GENERAL COMMENTS

In this paper, the authors present an application of a numerical model ROMS to a small bay in NE Spain in order to study the water renovation times and possible implications on water quality. The model is used to examine several coastal zone management scenarios that can be undertaken in order to improve the exchange of water in the bay. These include increased freshwater inputs from rice fields and a construction of an artificial channel of various widths through the Trabucador Bar in order to connect the inner Alfacs Bay with the sea. It is a very interesting contribution and the paper is well structured and easy to follow. Presentation of the results is clear, especially the figures and tables. It is also a very nice demonstration of the usefulness of having the Copernicus Marine Environment Monitoring Service as an enabler of downscaling of numerical models to a coastal zone in order to assist with the coastal zone management. I would like to see this paper published, as I think it will be of wide scientific interest. However, I recommend the following revisions to be undertaken by the authors before this paper is accepted for publication, especially that ther

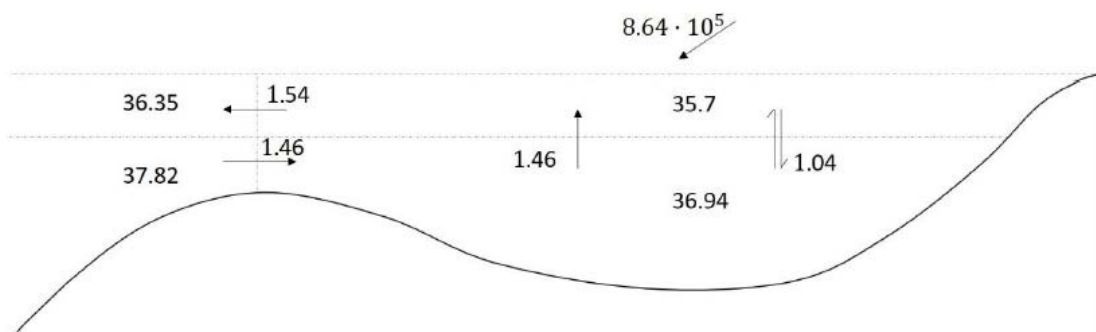
a. Related to comment 1(c) it would be good if authors included a Table with the values of S, Q and E used in the Officer (1980) box model.

Ok. We have added the information of the salinities in the different layers in the manuscript, whilst the Q from the rice fields was already described (10m3/s). We also have added in the response the figure summarizing the salinities and the corresponding flows from the model.
